Docket Item #7
BAR CASE #2010-0296

BAR Meeting
November 2, 2010

ISSUE: Permit to Demolish - Areaway
Waiver of Height Requirements - Fencing
Certificate of Appropriateness - Alterations (Window Replacement, Fence,
Deck and Areaway Construction)

LOCATION: 903 Green Street

Figure 5. Existing Elevations

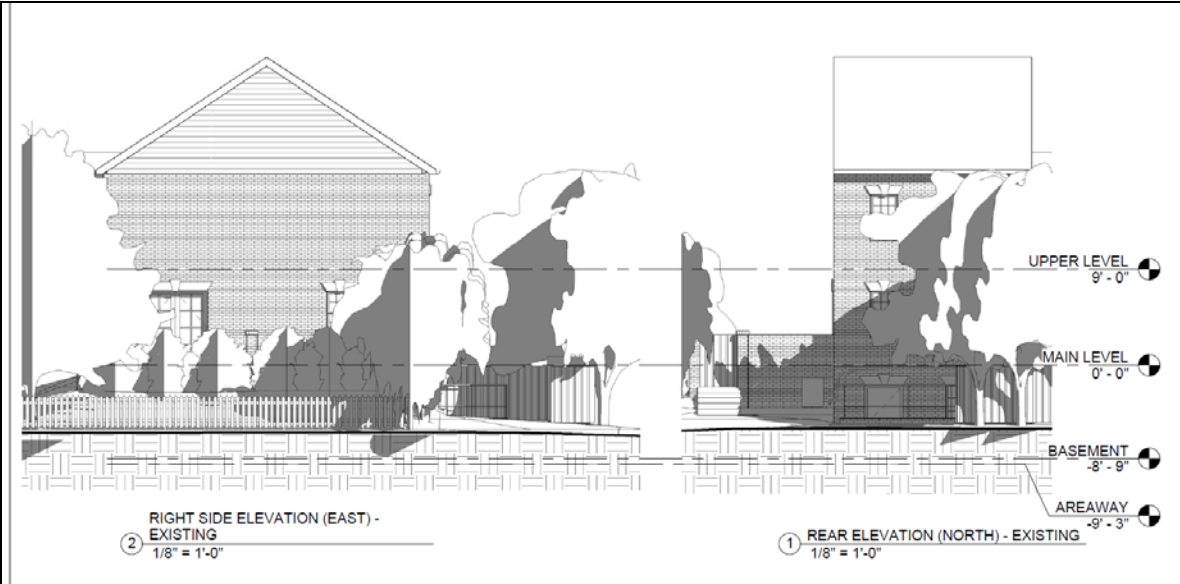
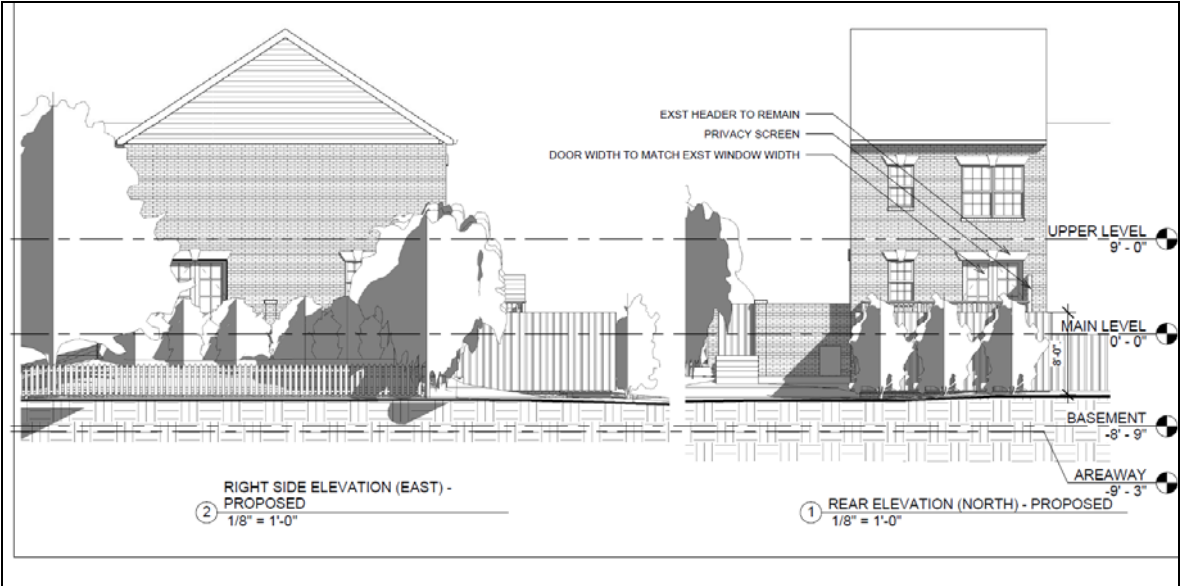
Therefore, given the age of the townhouse and the fact that the existing light pattern and size will be retained, Staff does not object to the installation of double-glazed wood windows and doors, with simulated divided lights. However, Staff does note that the application specifies a beaded profile for the muntins. Each proposed replacement window is evaluated against the draft *Alexandria Window Performance Specifications*. Staff finds that this profile does not meet the adopted *Alexandria Window Performance Specifications*, which requires the muntins to be detailed with a putty glaze profile. The proposed replacement windows appropriate and compatible with the surrounding buildings and consistent with the *Alexandria Window Performance Specifications*, if the proposed muntins are altered to a putty glaze profile.

Additionally, the *Guidelines* encourage exterior doors to be appropriate to the period of the structure. The proposed paired eight-light French doors are compatible with the existing architectural character of the building. The applicant's request to convert an existing window opening to a door on the rear elevation was initially a concern for staff. However, Staff finds that the proposal will not negatively impact the integrity of the resource as a whole, and considers the interchangeability of a window to a door while retaining the opening's width and the header a typical evolution for a building and a minor change to this secondary elevation. Staff supports this requested change.

The proposed demolition of a rear at grade areaway, the construction of a new areaway and wood deck are consistent with the *Design Guidelines*, as both are being constructed at the rear of the property and will not hide, obscure or cause the removal of historic architectural details. However, the *Guidelines* specify that open decks are generally only appropriate on buildings post dating ca.1950. Staff believes that the proposed location on the rear elevation and after the construction of the proposed fence, the deck and areaway will be minimally visible from the public right-of-way. The *Guidelines* however, do require that decks should be painted or stained the predominant color of the building or the color of the trimwork.

1. The muntins on the new windows and French doors contain a putty profile.
2. The new fence be located entirely on the subject property and be painted or stained.
3. The new deck be painted or stained.
